Our Ref: 450-LT-01-Response to LLFA Comments

Your Ref: ERE/0722/0038

**Re: Response to LLFA Comments dated 12<sup>th</sup> August 2022**

This letter has been drafted to provide additional supporting information for the MAC report ref 450-FRA-01-0-Flood Risk Assessment-Sowbrook Lane, Ilkeston; in response to LLFA email correspondence received from Derbyshire County Council LLFA on 12<sup>th</sup> August 2022, for application reference ERE/0722/0038. The additional information requested/ comments made by the LLFA are highlighted in bold below, and the MAC responses are provided after each number point.

Appendix A – Stage-Discharge Calculations and Flood Zone Extent Drawings

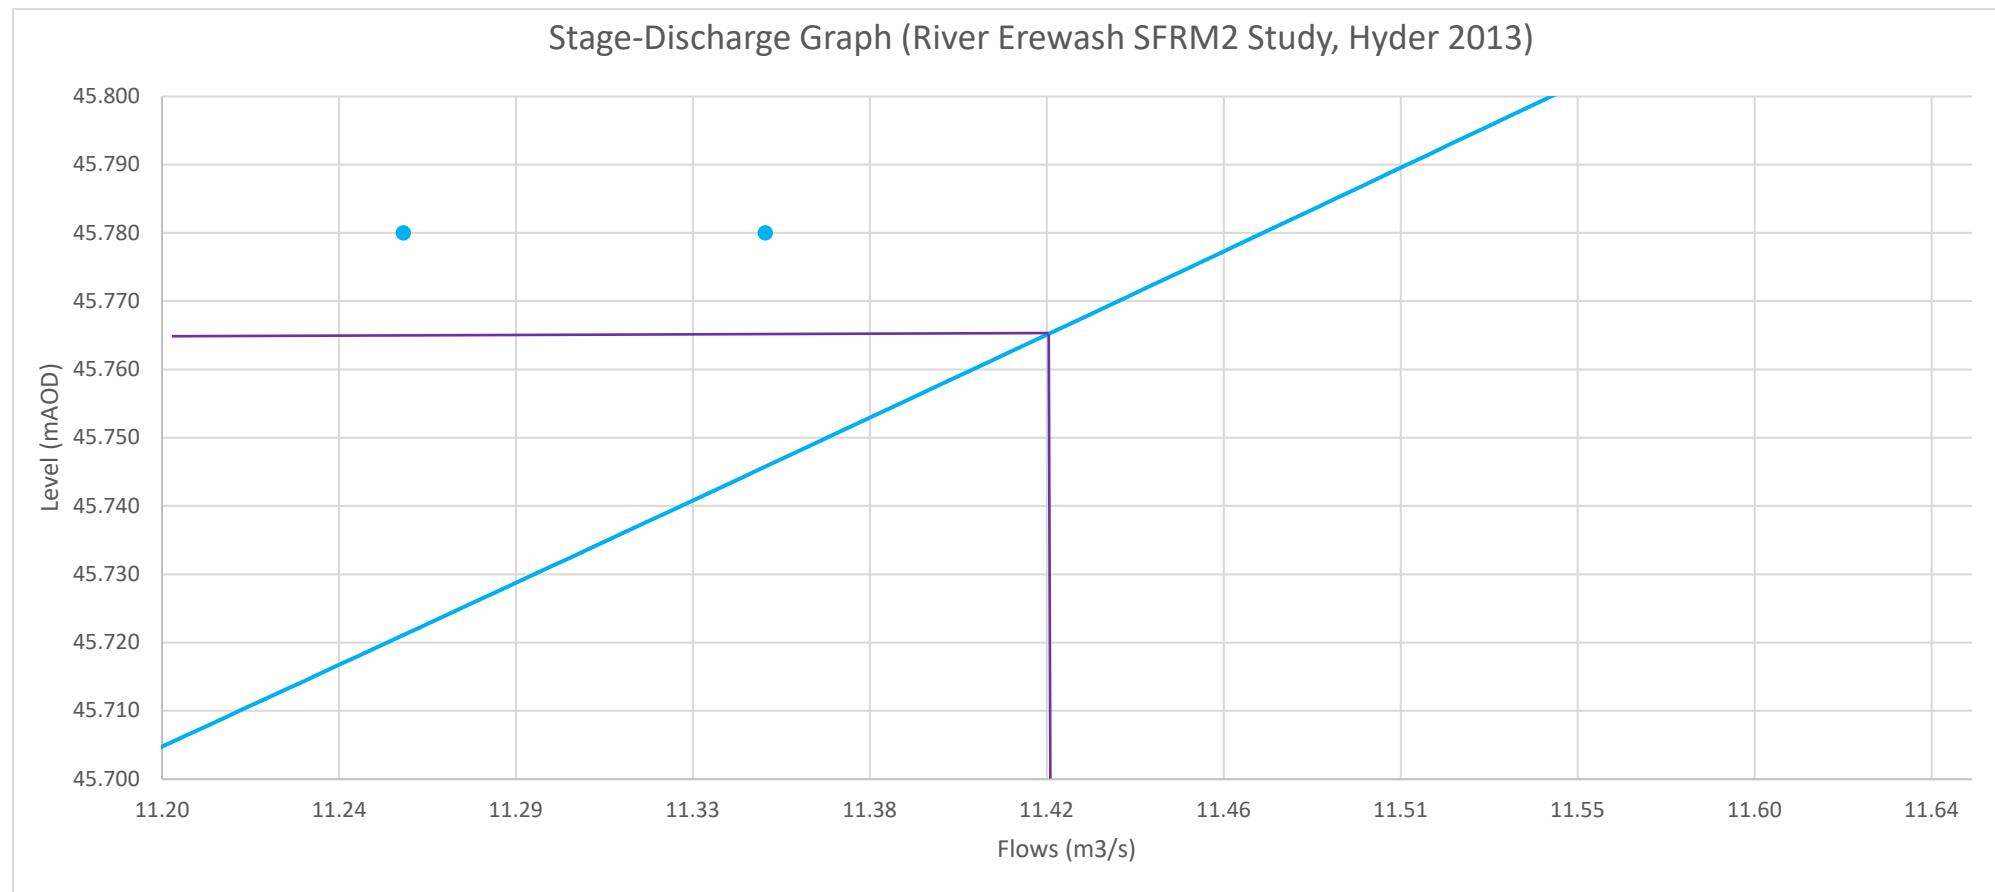
**1. Are the retention basin's within Flood zone 2 or 3? If so how do you expect they will operate during such flood events?**

The proposed basins are neither located in Flood Zone 2 or 3, they are in Flood Zone 1. Within the submitted Flood Risk Assessment report, a Stage-Discharge calculation was carried out using flood level information provided by the Environment Agency for the adjacent Nutbrook Canal. Based on the information provided, the full extent of the application's red line is situated at a higher elevation than the 1 in 1,000-year equivalent flood level predicted within the immediate vicinity (46.150mODN). See **Appendix A** for a copy of the Stage-Discharge calculation and the associated drawings which highlight the extents for each Flood Zone based on the Environment Agency data.

Existing Overland Flow Path  
MAC drawing no. 450-FRA08

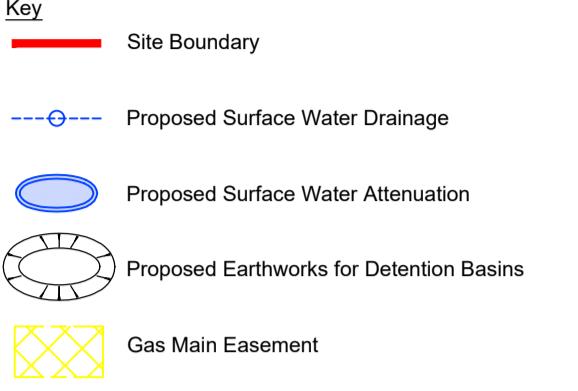
3. **Can you confirm the condition of the outfall location and its suitability to accept the point discharge of the entire site? Currently more than half the site would not drain to this point. Additionally, the LLFA hold no modelling data for the ordinary watercourse to the West of the site, and the FRA has not adequately assessed the risk that these water course may pose to the site.**

4. **There is an outfall marked to East of the site on Ilkeston road which also feeds a fish pond, is it possible that this pond also relies on water from the site to feed the pond? The topo and surface water maps also indicated water from the site would head in that direction.**

Yes, we believe the outfall location is suitable. A 3D model of the site has been created based on topographic survey information. Directional fall arrows and associated gradients have been superimposed onto the 3D model. See the drawing included as **Appendix B** for further details. Based on the directional fall arrows shown in **Appendix B**, it is reasonable to conclude that the ultimate outfall for the site is Nutbrook Canal.

Based on the drawing included as **Appendix B**, only a small proportion of the site directs runoff to the east. Given that the eastern site boundary is located directly adjacent to Ilkeston Road, it is likely that any runoff currently directed in an eastern direction, would be intercepted by the road gullies within the main carriageway. The ultimate outfall for these road gullies is present unknown; however, it is more likely that the outfall point will connect to Nutbrook Canal, as opposed to the fishing pond.
